Project	IEEE 802.16 Broadband Wireless Access Working Group < http://ieee802.org/16 >		
Title	Training for AAS		
Date Submitted	2003-09-09		
Source(s)	Naftali Chayat, Tal Kaitz - Alvarion	Voice:	+972 54 22 56 48
	John Liebetreu - Intel	Fax:	+972 3 6456273
		mailto:	Naftali.Chayat@alvarion.com
Re:	IEEE 802.16d Sponsor Ballot		
Abstract	Training for reception of simultaneous transmissions requires that those can be discriminated, preferably at the training stage. This calls for the ability to modify the preambles so that channel from more than user can be studied. We propose cyclic time-shifting of the preamble as such modifier		
Purpose	Enhancing the AAS training mechanism		
Notice	This document has been prepared to assist IEEE 802.16. It is offered as a basis for discussion and is not binding on the contributing individual(s) or organization(s). The material in this document is subject to change in form and content after further study. The contributor(s) reserve(s) the right to add, amend or withdraw material contained herein.

AAS training enhancement

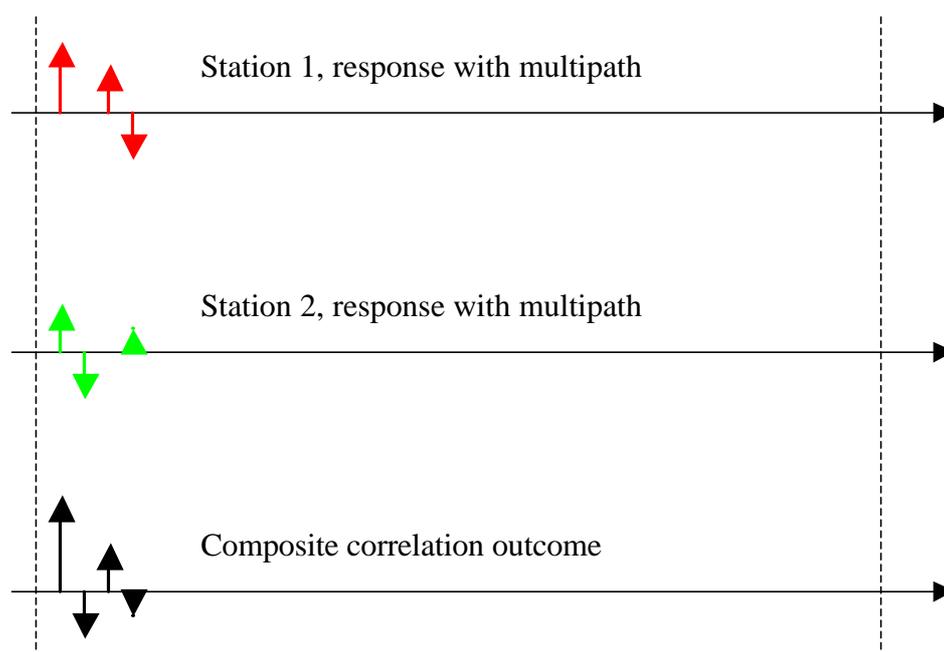
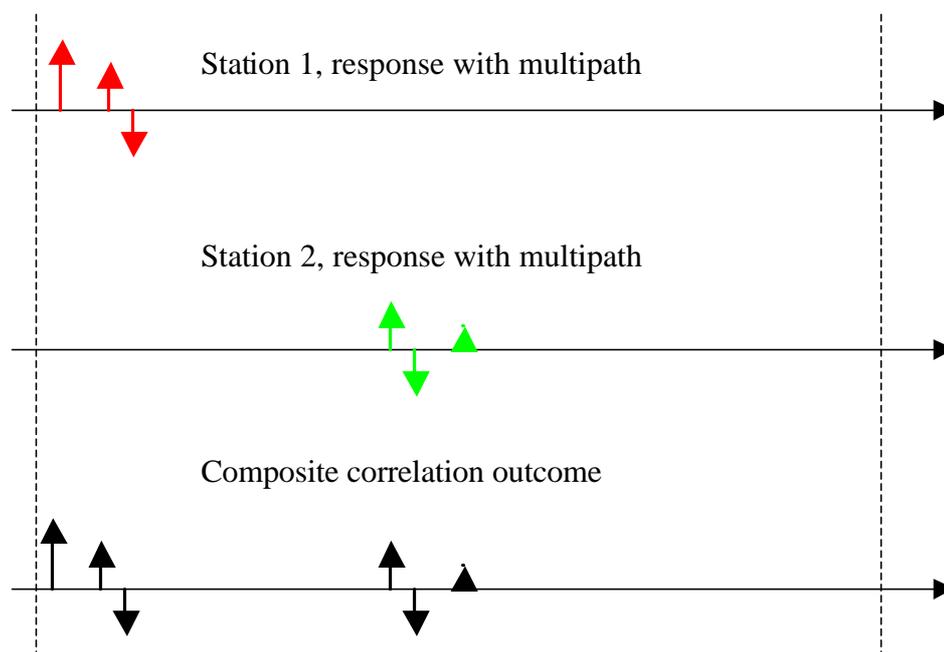
One way to introduce such property into the preambles is to time-shift them. As a simplistic example, let us look at the case that two stations transmit same training sequence simultaneously, without the time shift. The base station performs a cyclic correlation of the received waveform with the preamble. The result is illustrated in the drawing below.

As we see in the illustrative figure, the base station sees one composite response, in which it is not able to identify the contributions of the two stations separately.

In the case that the training sequences are transmitted with a cyclic time shift, the picture looks differently:

In this case the base station can identify the contribution of the two stations and perform a processing which will discriminate the transmissions of the stations.
